# Appendix R

*Public Involvement Plan*

## IR-71/IR-271 Planning Study in Medina County

Project PID 117028

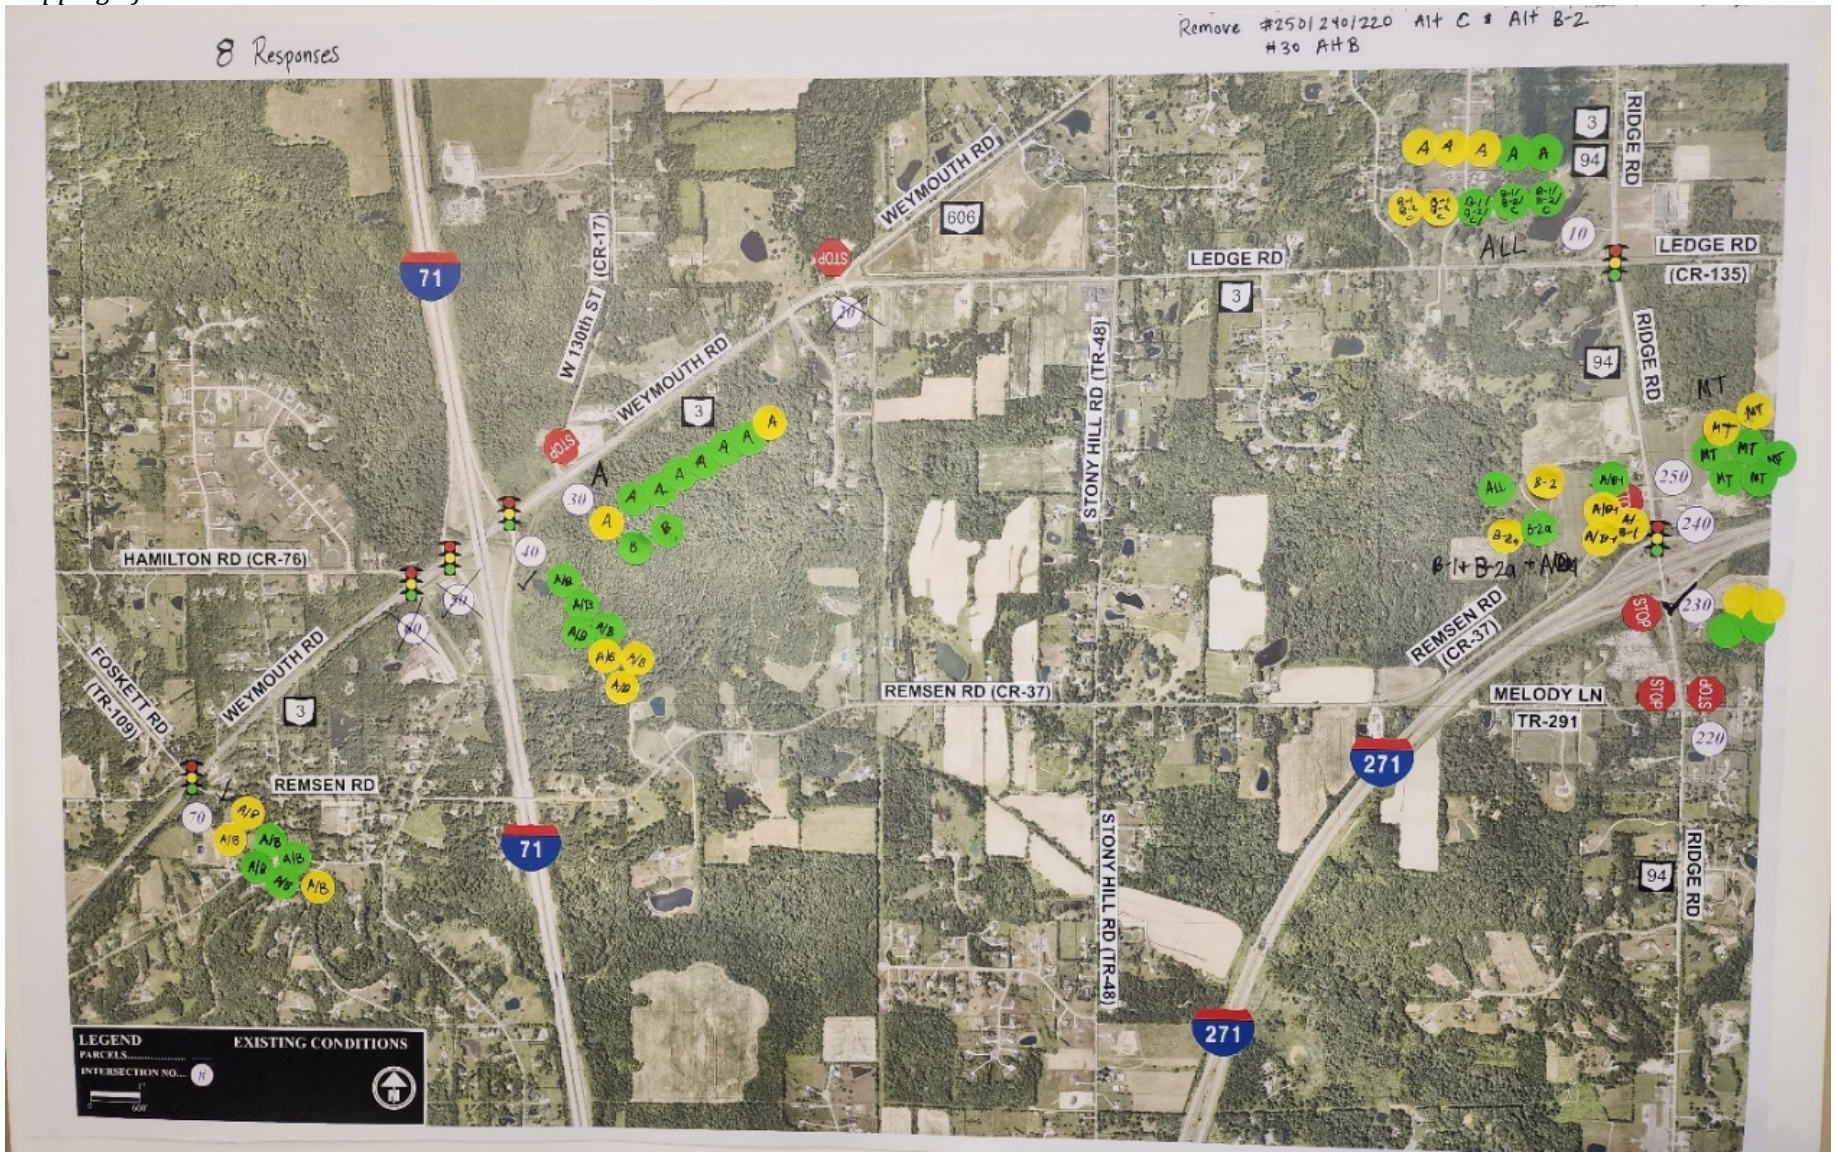
- Resident requested the diminishing lane from SB I-71 to EB I-271 to be continued.
- Resident is in favor of further study on SR-94 improvements.
- Resident is in favor of improvements on SR-3 and SR-94.
- Resident is not in favor of improvements on SR-3 and SR-94. They felt that that improvement wouldn't benefit Ledge Road traffic.

- ODOT stated that traffic circles are normally designed for heavy trucks. ODOT is now looking at other types of traffic (e.g., special tractor trailers, long campers, trucks carrying wind turbine blades).
- The bridge over I-271 is not a popular improvement due to cost and traffic disruption.

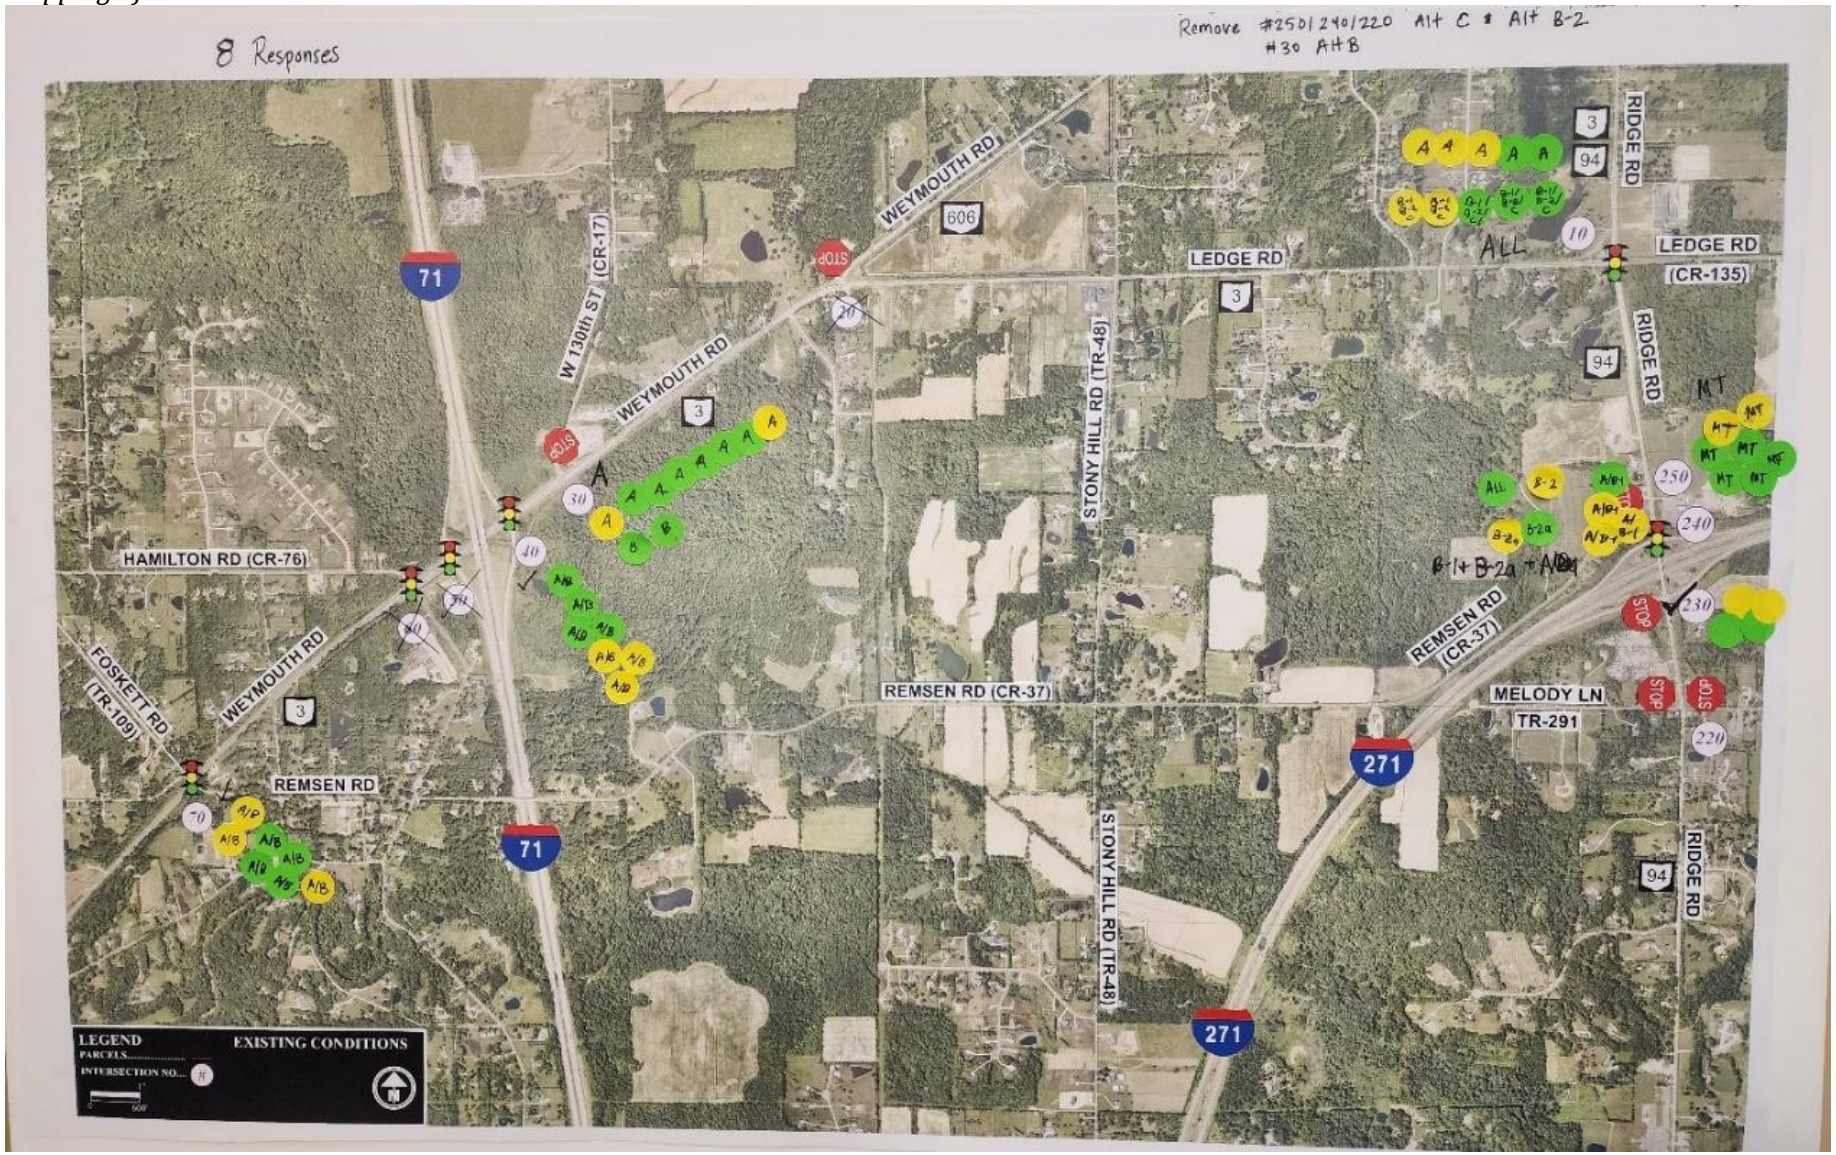
- Resident requested the diminishing lane from SB I-71 to EB I-271 to be continued.
- Resident is in favor of further study on SR-94 improvements.
- Resident is in favor of improvements on SR-3 and SR-94.
- Resident is not in favor of improvements on SR-3 and SR-94. They felt that that improvement wouldn't benefit Ledge Road traffic.
